UNITED STATES PATENT AND TRADEMARK OFFICE

APPLICATION NO.	FILING DATE	FIRST NAMED INVENTOR	ATTORNEY DOCKET NO.	CONFIRMATION NO.
10/516,486	05/18/2005	John McGuire	MCGJ101NUS	2842
21658	7590	12/04/2006	EXAMINER	
DYKAS, SHAVER & NIPPER, LLP P.O. BOX 877 BOISE, ID 83701-0877			DUCKWORTH, BRADLEY	
			ART UNIT	PAPER NUMBER

Office Action Summary

DETAILED ACTION

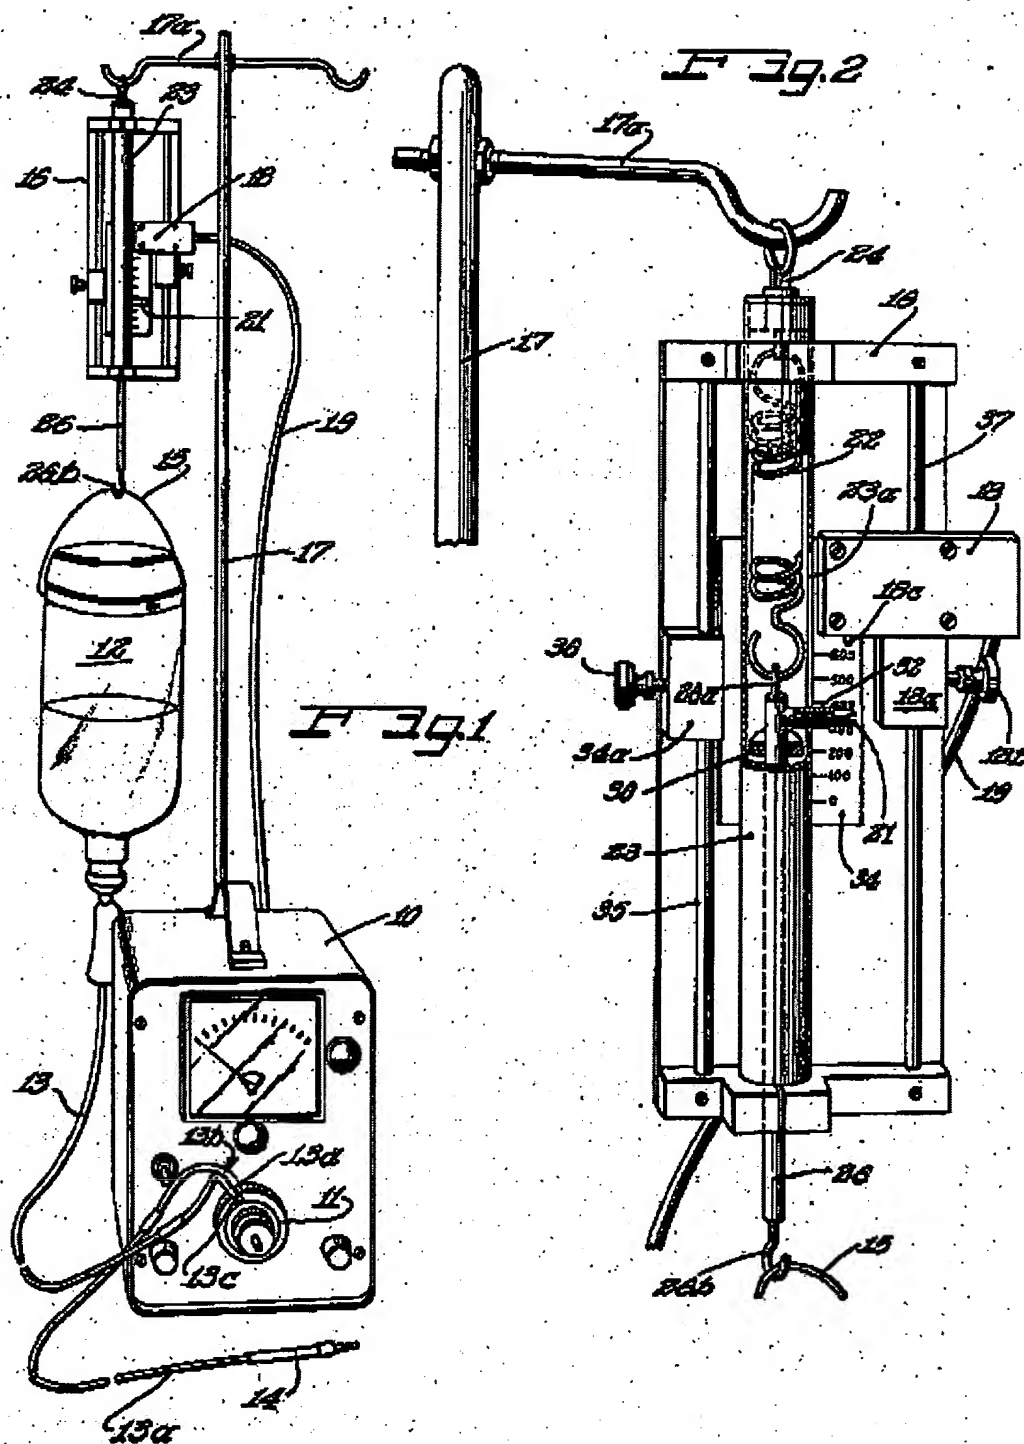
Claims 1,2,4, and 20 are rejected under 35 U.S.C. 102(b) as being anticipated by Gordon et al.(US003425415). Gordon teaches a controlled infusion system, referring to figures 1 and 2, comprising an indicator means(34), a first component with attachment means (26B) for a drip bag, that can move relative to a second component(17) in a substantially vertical direction, whereby movement of the first component activates the

Fig. 1

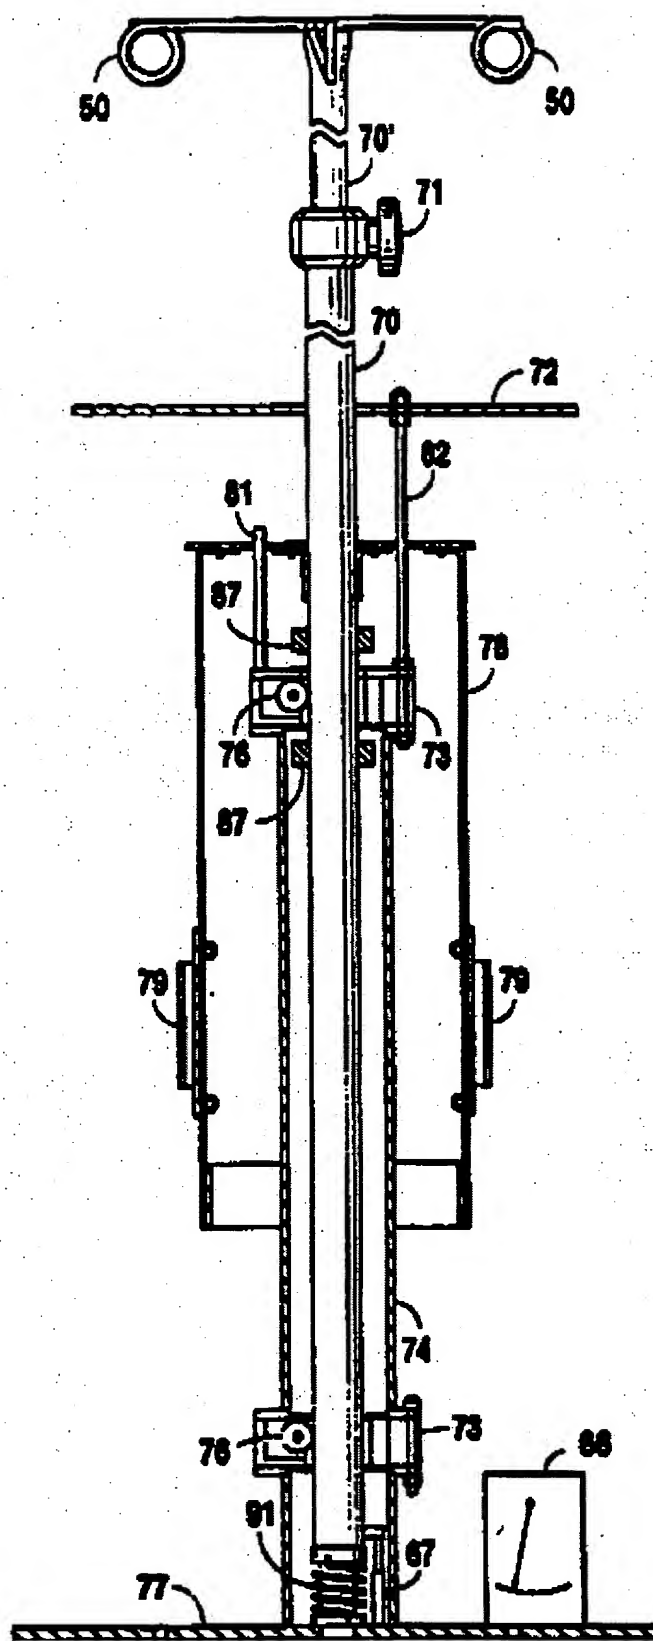
Claims 1,2,3,4,5,6,7,10,11, and 15 are rejected under 35 U.S.C. 102(b) as being anticipated by Vancaillie et. Al.(US005956130). Referring to figure 1, Vancaillie teaches a stand, comprising indicator means(67) a first component(70) with attachment means for a medical bag(50) and is adapted to move in a substantially vertical direction relative to a second component(74) where the movement of the first component activates the indicator means, the two components comprising hollow tubular sections, where the first component is positioned above and substantially within the top of the second section, where the lower region of the first section has a diameter smaller then that of the diameter of the uppermost section of the second component. The stand further comprising a compression spring(91) located in the second component where the first component makes contact with and sits on the compression spring. The indicator means mentioned above, in the embodiment of figure 1, comprise a means to measure the weight induced compression of the spring(91) whereby the means sends a signal to a computing means which activates either one or more of an indicator light or audible alarm, as detailed in the first paragraph of column 21 among other places, when the spring either compresses(weight added, i.e. medical bag filling) or extends(weight lost, i.e. medical bag emptying) past a predetermined point.

Fig. 4

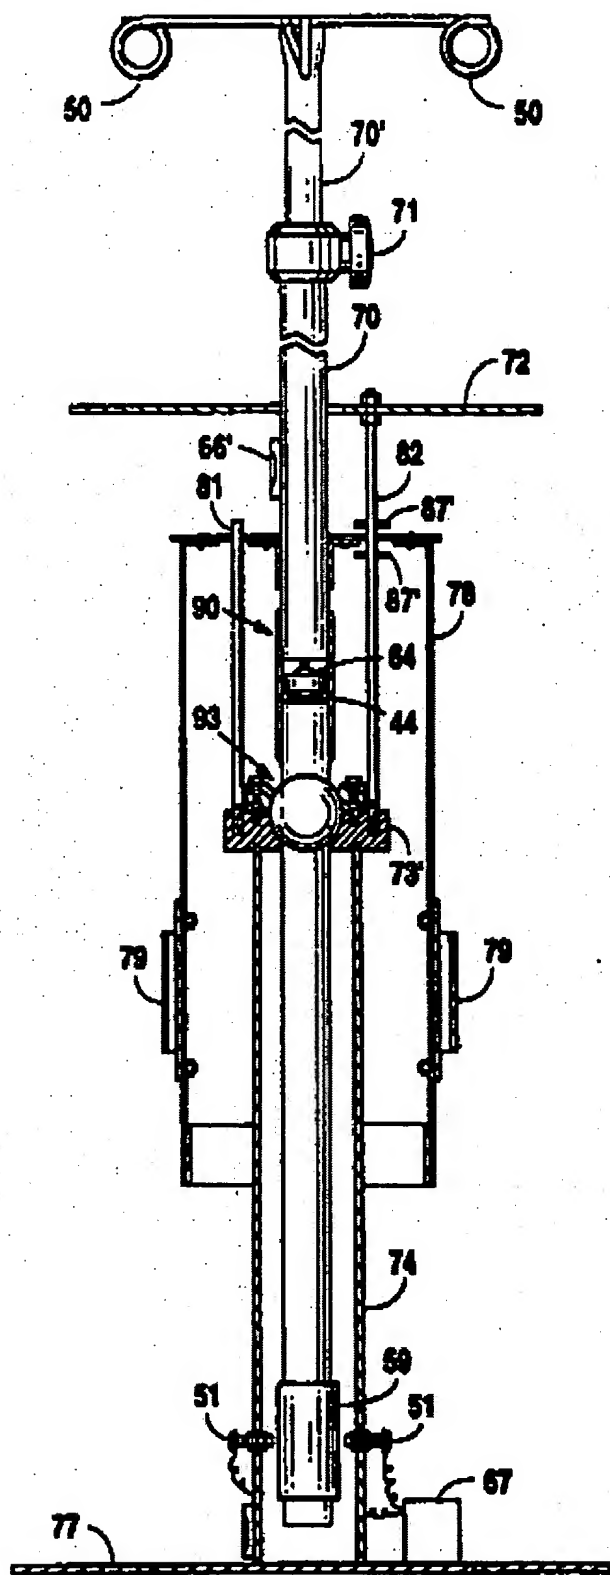
Claims 1,8 and 9 rejected under 35 U.S.C. 102(b) as being anticipated by Vancaillie. Vancaillie teaches another embodiment of a stand, as shown in figure 4, comprising an indicator means(here 64,51, and 67) where movement of a first component, taken as rod(70) upto load cell(64) including casing(78) and means to hold a medical bag(50), relative to a second component(74), whereby the lowermost region of the first component(78) is substantially over the uppermost region of the second component, where the diameter of the lowermost region of the first component is larger than the diameter of the uppermost region of the second component.

Fig. 81

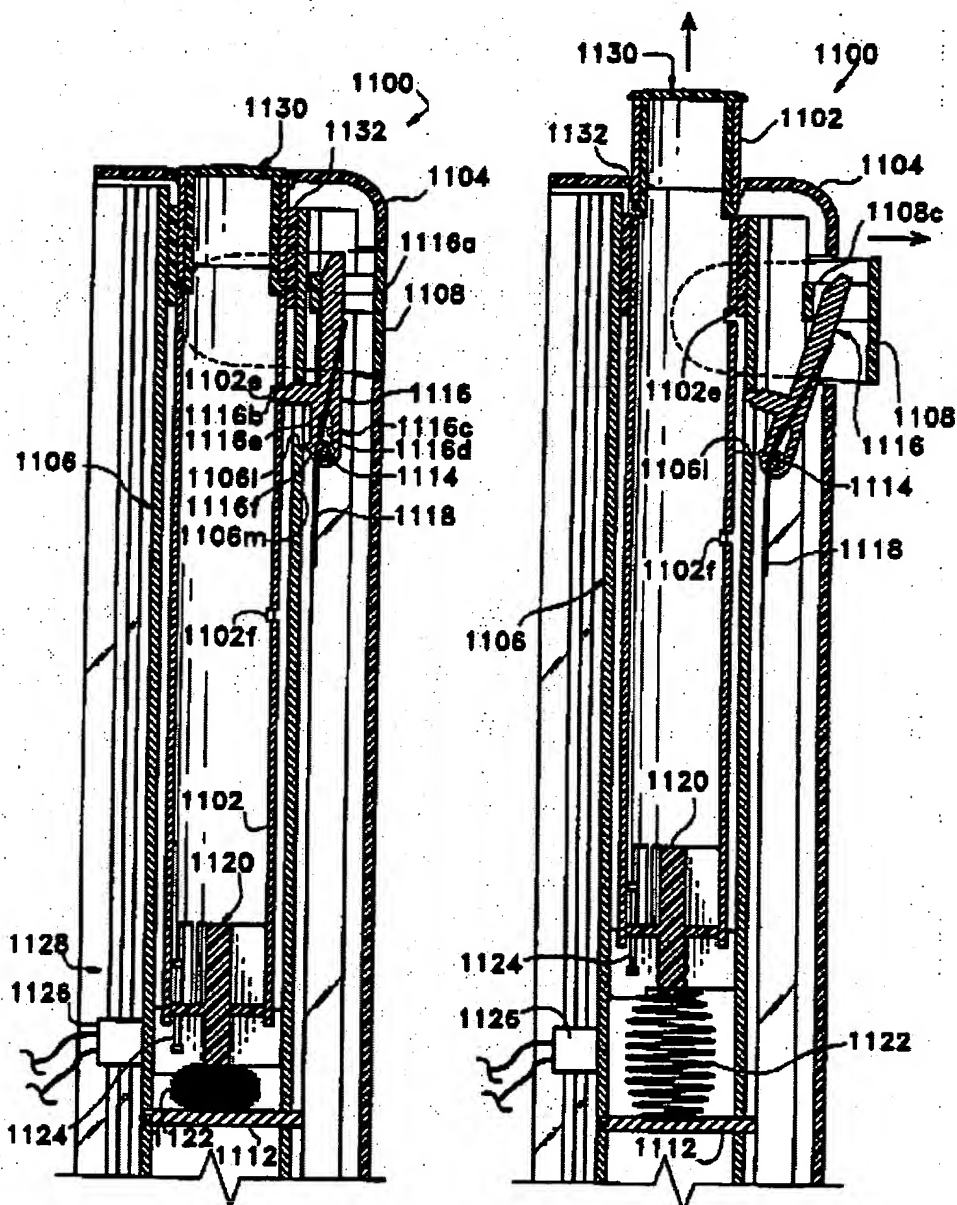
system comprising a telescoping rod assembly as shown in figures 81 and 82. The rod assembly is equipped with a magnetic array (1124) and a reed switch(1126) with the magnetic array on a first component(1102) and the reed switch on a second component(1106), and a spring (1122) on the second component with the first component resting thereon, where the magnetic array in proximity of the reed switch activates an alarm as detailed in paragraphs 141, 251 and 252 of the disclosure.
